Re: Improving the Safety, Comfort, and Character of I-35 Frontage Roads

Our request is straightforward: build a frontage network that is safe, shaded, and multimodal on Day 1, and formalize the collaboration to achieve it. Specifically, AIA Austin asks TxDOT to:

I-35 CapEx Central Project

Cross-Section of West Edge of ROW between E 3rd St & E 4th St, Looking North

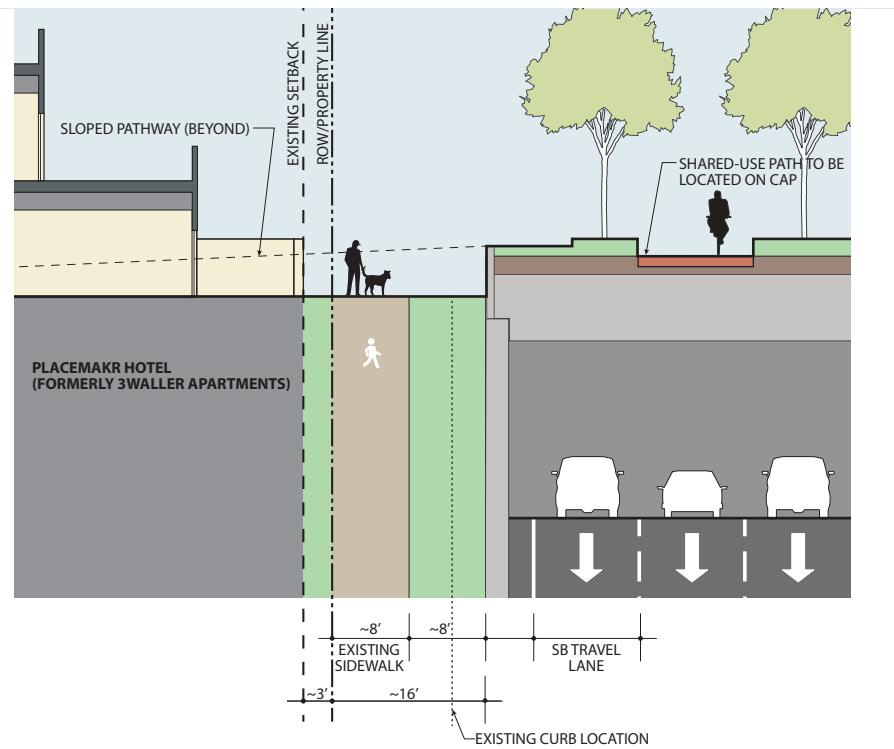
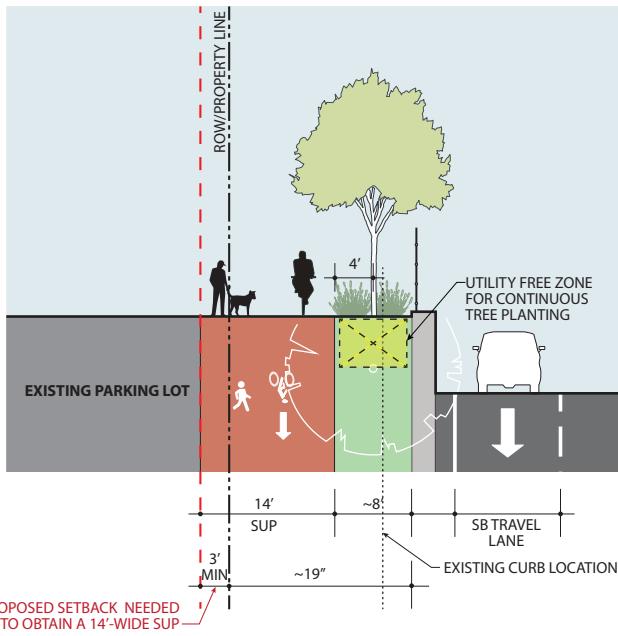
- The TxDOT Design is a cross-sectional depiction of the plan view roll-plots of the 8.5.2025 Design, as posted on the txdot.gov/mymobility35/projects/capex-central.html website. As no cross-sections or elevational information were provided, this cross-section is conceptual only.
- A minimum Utility Free Zone of 7' wide X 5' deep is required to allow for shade trees to be planted in a continuous trench, per the Concept Tree Planting Detail found at the end of this package. It is critical to ensure that no underground utilities are located within this zone.
- Trees planted in a continuous trench each require a minimum soil volume of 750 cu ft. Individually-planted trees require a min. soil volume of 1,000 cu ft.

Cross-Section of West Edge of ROW between E 4th St & E 5th St, Looking North

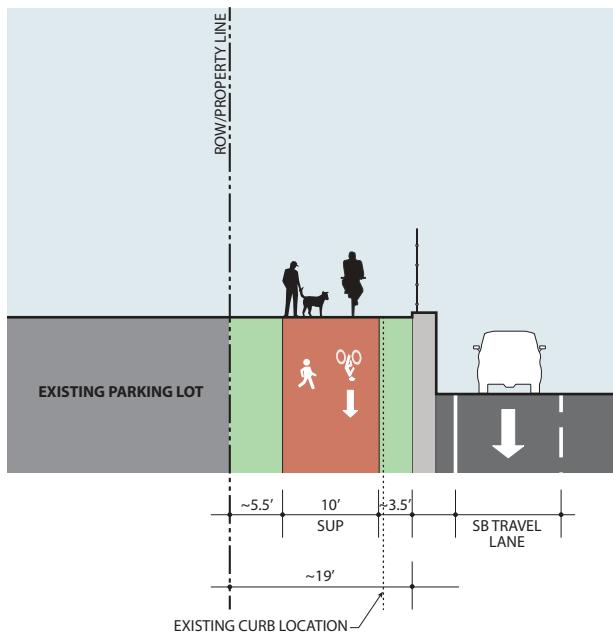
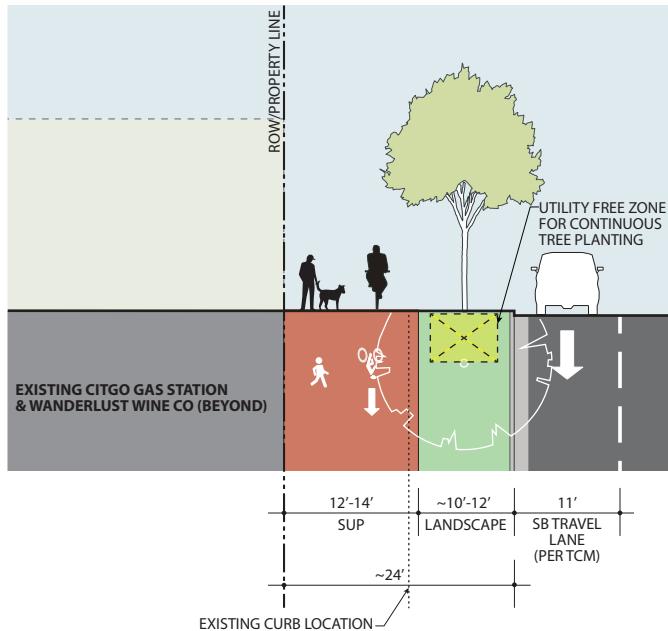
- The TxDOT Design is a cross-sectional depiction of the plan view roll-plots of the 8.5.2025 Design, as posted on the txdot.gov/mymobility35/projects/capex-central.html website. As no cross-sections or elevational information were provided, this cross-section is conceptual only.
- A minimum Utility Free Zone of 7' wide X 5' deep is required to allow for shade trees to be planted in a continuous trench, per the Concept Tree Planting Detail found at the end of this package. It is critical to ensure that no underground utilities are located within this zone.
- Trees planted in a continuous trench each require a minimum soil volume of 750 cu ft. Individually-planted trees require a min. soil volume of 1,000 cu ft.

Cross-Section of West Edge of ROW between E 6th St & E 7th St, Looking North

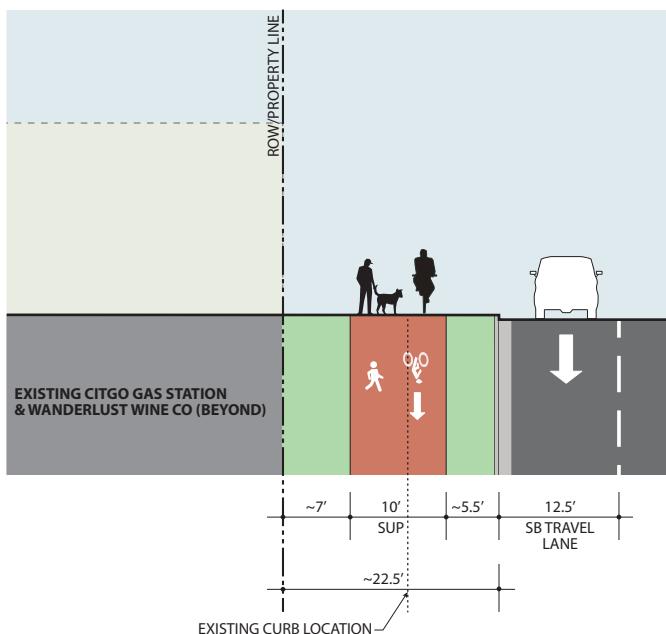
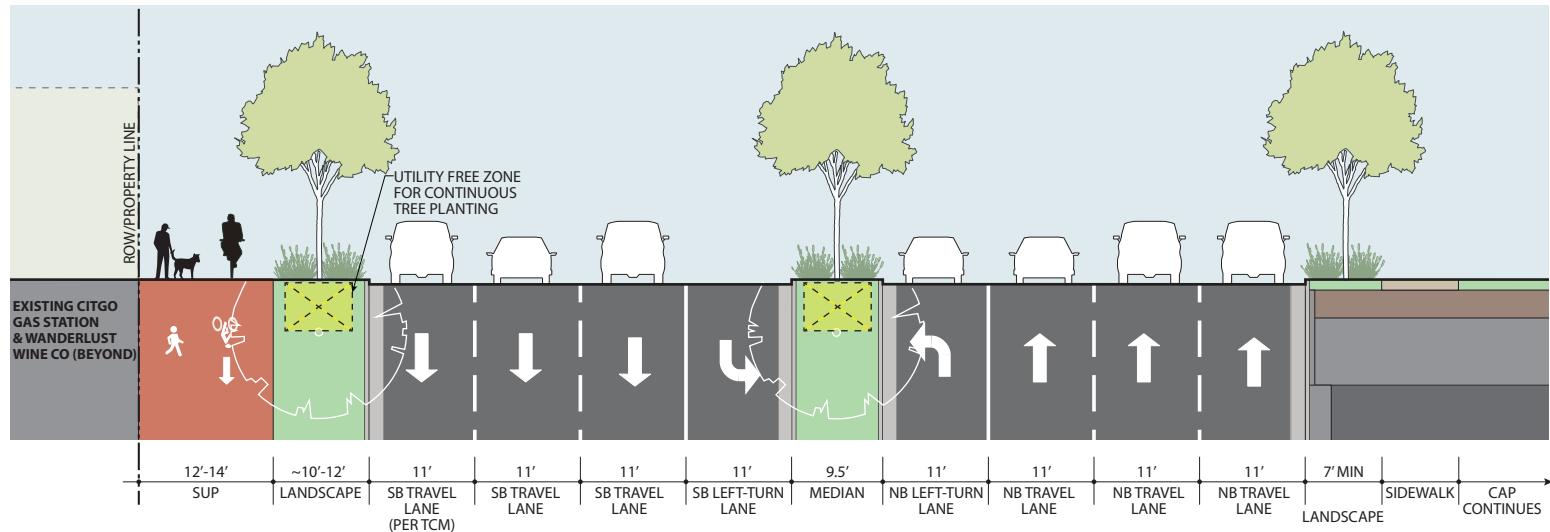
- The TxDOT Design is a cross-sectional depiction of the plan view roll-plots of the 8.5.2025 Design, as posted on the txdot.gov/mymobility35/projects/capex-central.html website. As no cross-sections or elevational information were provided, this cross-section is conceptual only.
- A minimum Utility Free Zone of 7' wide X 5' deep is required to allow for shade trees to be planted in a continuous trench, per the Concept Tree Planting Detail found at the end of this package. It is critical to ensure that no underground utilities are located within this zone.
- Trees planted in a continuous trench each require a minimum soil volume of 750 cu ft. Individually-planted trees require a min. soil volume of 1,000 cu ft.

Cross-Section of Frontage Road between E 6th St & E 7th St at Mid-Block, Looking North

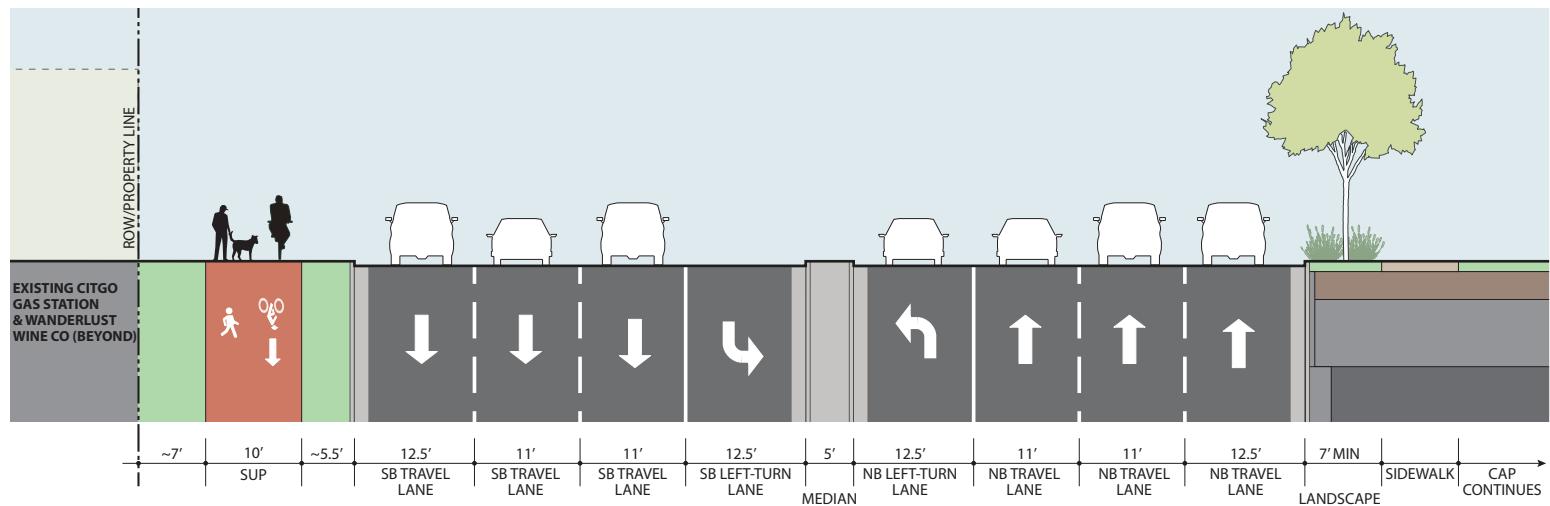
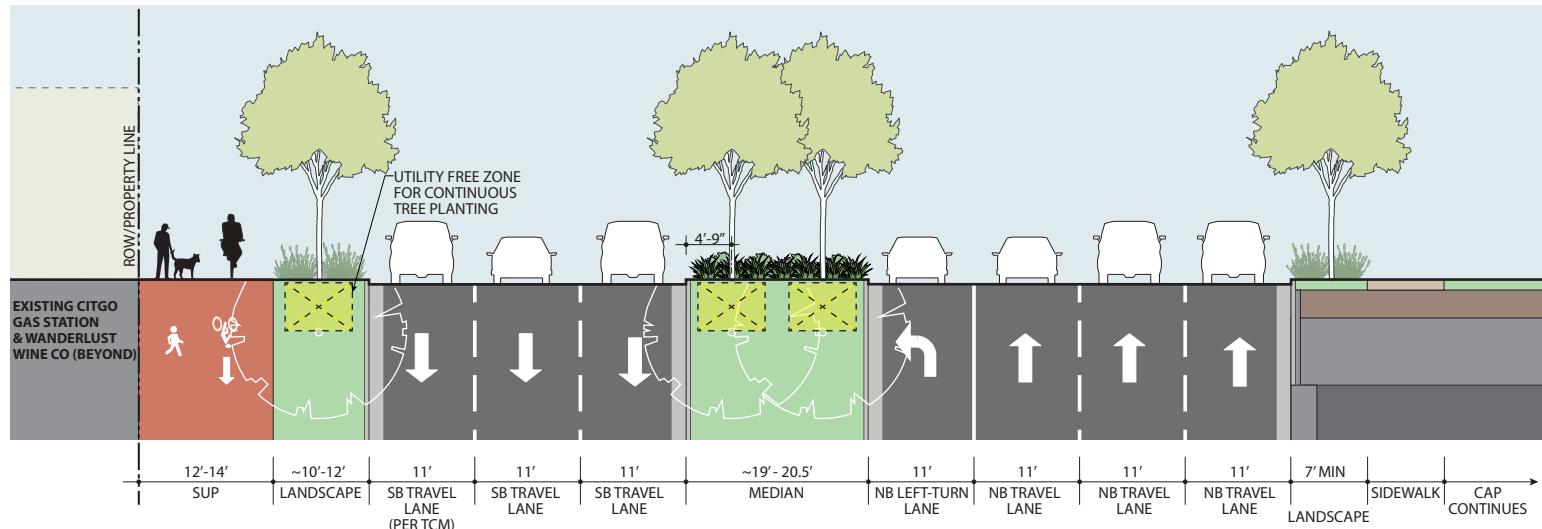
- The TxDOT Design is a cross-sectional depiction of the plan view roll-plots of the 8.5.2025 Design, as posted on the txdot.gov/mymobility35/projects/capex-central.html website. As no cross-sections or elevational information were provided, this cross-section is conceptual only.
- A minimum Utility Free Zone of 7' wide X 5' deep is required to allow for shade trees to be planted in a continuous trench, per the Concept Tree Planting Detail found at the end of this package. It is critical to ensure that no underground utilities are located within this zone.
- Trees planted in a continuous trench each require a minimum soil volume of 750 cu ft. Individually-planted trees require a min. soil volume of 1,000 cu ft.

Cross-Section of Frontage Road between E 6th St & E 7th St at Intersection, Looking North

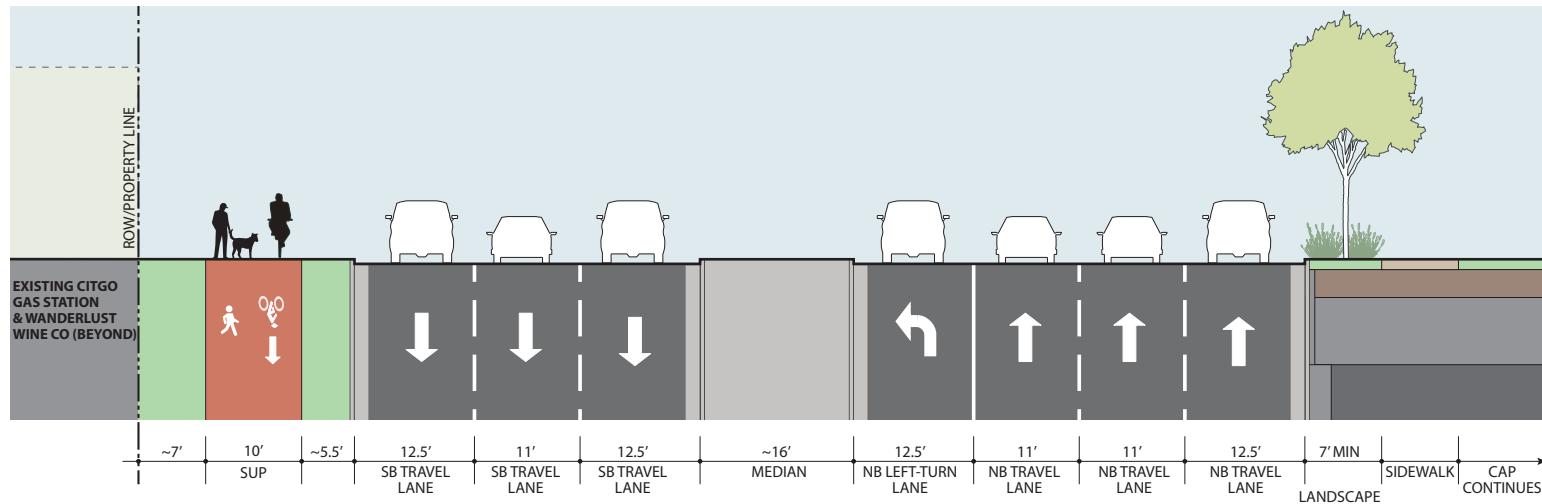
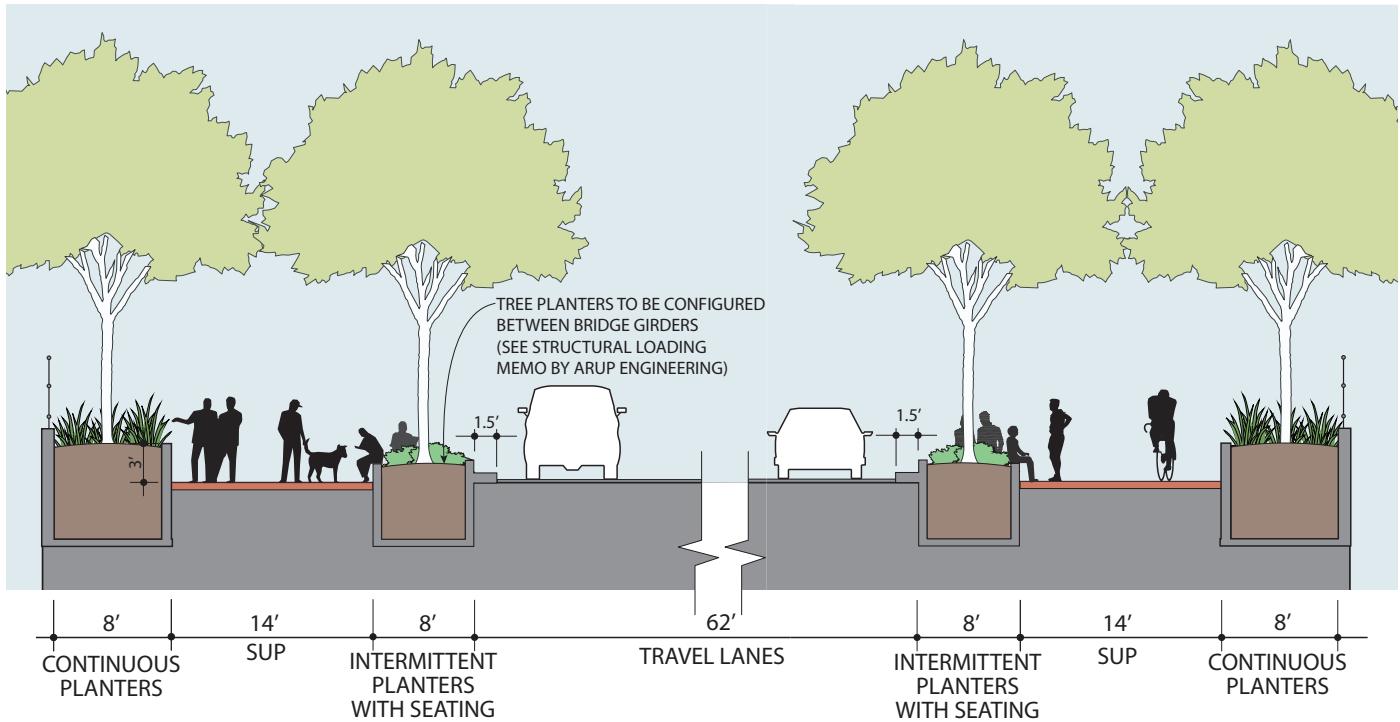
- The TxDOT Design is a cross-sectional depiction of the plan view roll-plots of the 8.5.2025 Design, as posted on the txdot.gov/mymobility35/projects/capex-central.html website. As no cross-sections or elevational information were provided, this cross-section is conceptual only.
- A minimum Utility Free Zone of 7' wide X 5' deep is required to allow for shade trees to be planted in a continuous trench, per the Concept Tree Planting Detail found at the end of this package. It is critical to ensure that no underground utilities are located within this zone.
- Trees planted in a continuous trench each require a minimum soil volume of 750 cu ft. Individually-planted trees require a min. soil volume of 1,000 cu ft.

Cross-Section through E Cesar Chavez St Bridge, Looking West

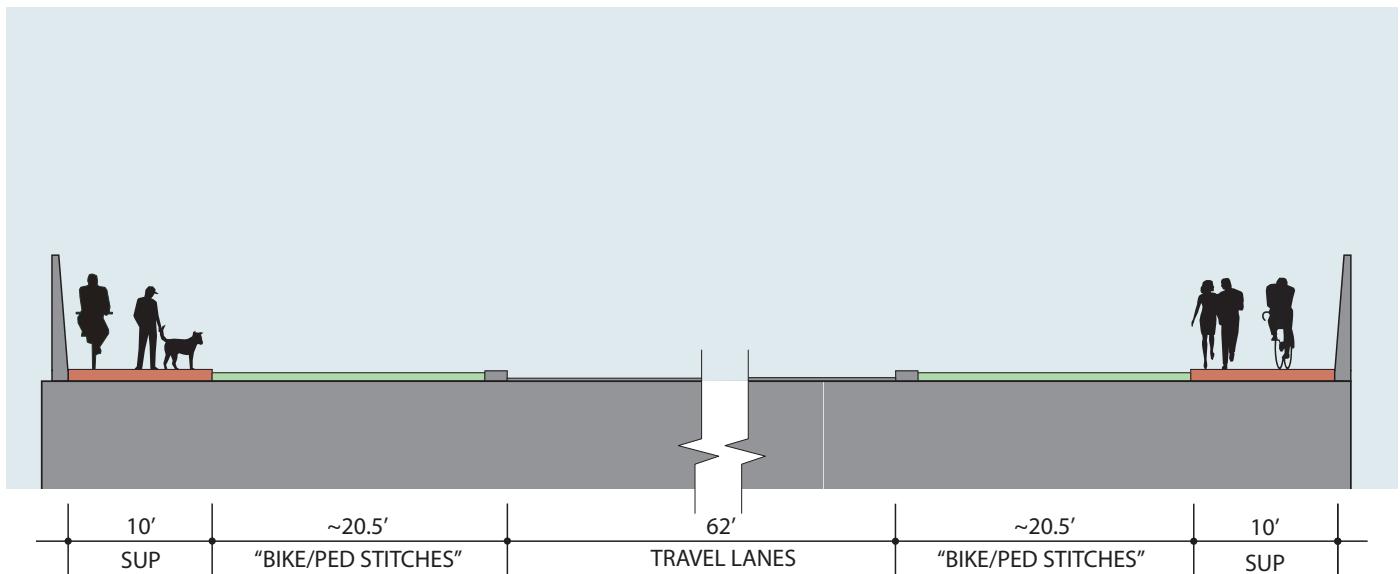
- The TxDOT Design is a cross-sectional depiction of the plan view roll-plots of the 8.5.2025 Design, as posted on the txdot.gov/mymobility35/projects/capex-central.html website. As no cross-sections or elevational information were provided, this cross-section is conceptual only.
- Trees planted in a continuous trench each require a minimum soil volume of 750 cu ft. Individually-planted trees require a min. soil volume of 1,000 cu ft.

I-35 CapEx Central Project Cross-Section of East Avenue Trail at E 10 St, Looking North

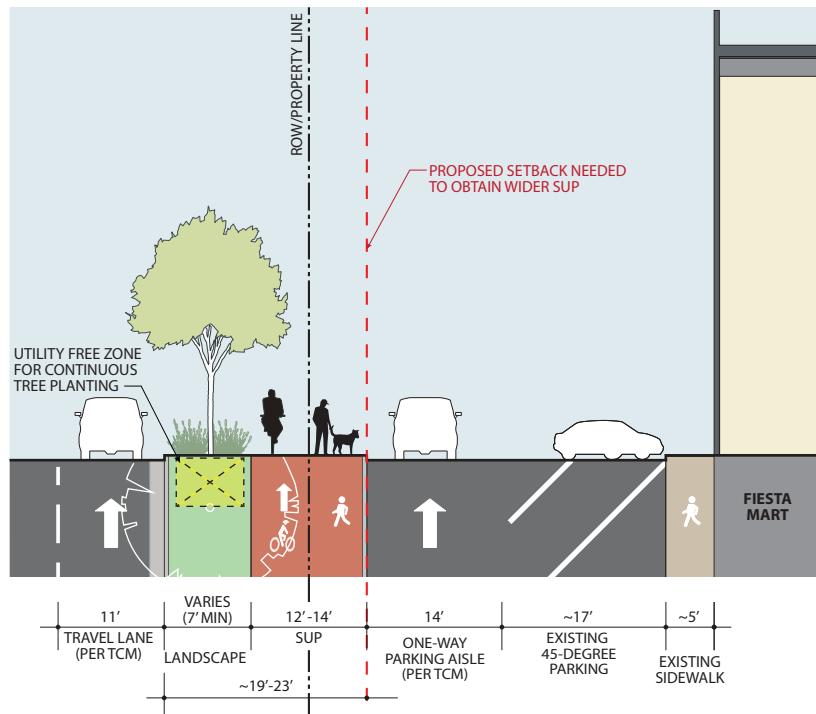
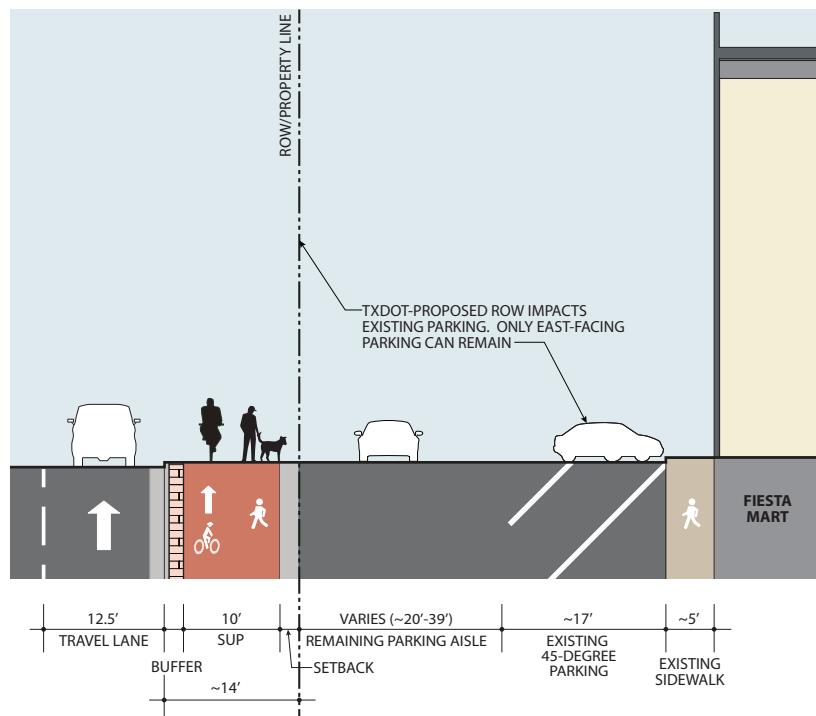
- The TxDOT Design is a cross-sectional depiction of the plan view roll-plots of the 8.5.2025 Design, as posted on the txdot.gov/mymobility35/projects/capex-central.html website. As no cross-sections or elevational information were provided, this cross-section is conceptual only.
- A minimum Utility Free Zone of 7' wide X 5' deep is required to allow for shade trees to be planted in a continuous trench, per the Concept Tree Planting Detail found at the end of this package. It is critical to ensure that no underground utilities are located within this zone.
- Trees planted in a continuous trench each require a minimum soil volume of 750 cu ft. Individually-planted trees require a min. soil volume of 1,000 cu ft.

Cross-Section of East Avenue Trail at Fiesta Mart / E 40th St, Looking North

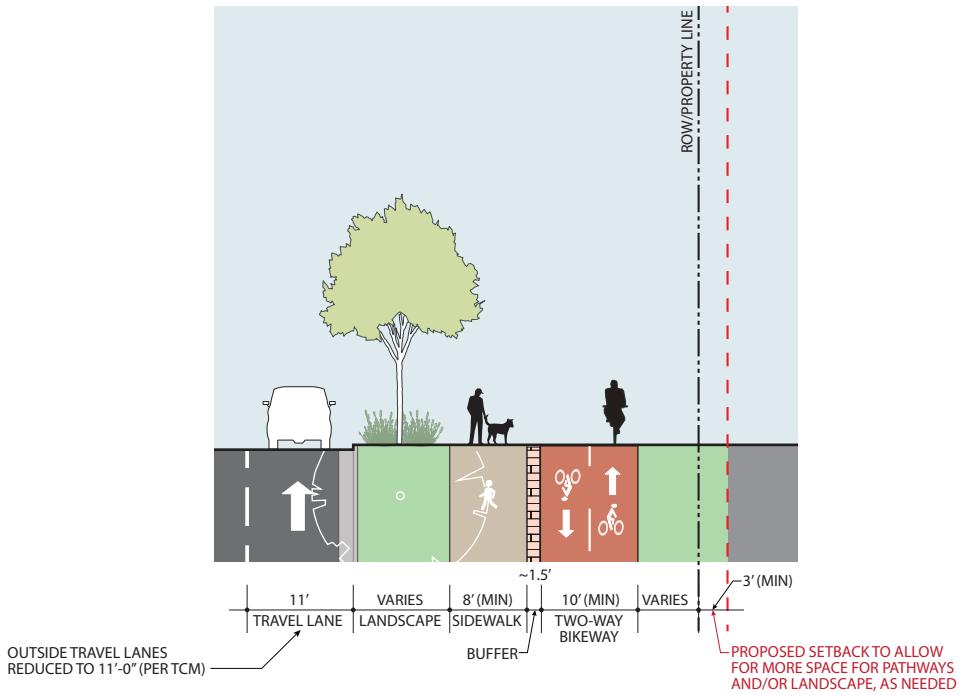
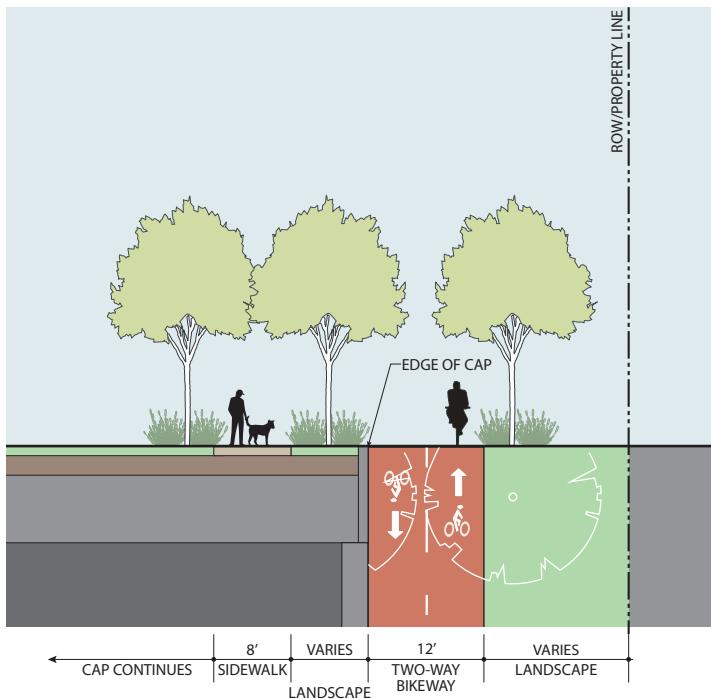
- The TxDOT Design is a cross-sectional depiction of the plan view roll-plots of the 8.5.2025 Design, as posted on the txdot.gov/mymobility35/projects/capex-central.html website. As no cross-sections or elevational information were provided, this cross-section is conceptual only.
- A minimum Utility Free Zone of 7' wide X 5' deep is required to allow for shade trees to be planted in a continuous trench, per the Concept Tree Planting Detail found at the end of this package. It is critical to ensure that no underground utilities are located within this zone.
- Trees planted in a continuous trench each require a minimum soil volume of 750 cu ft. Individually-planted trees require a min. soil volume of 1,000 cu ft.
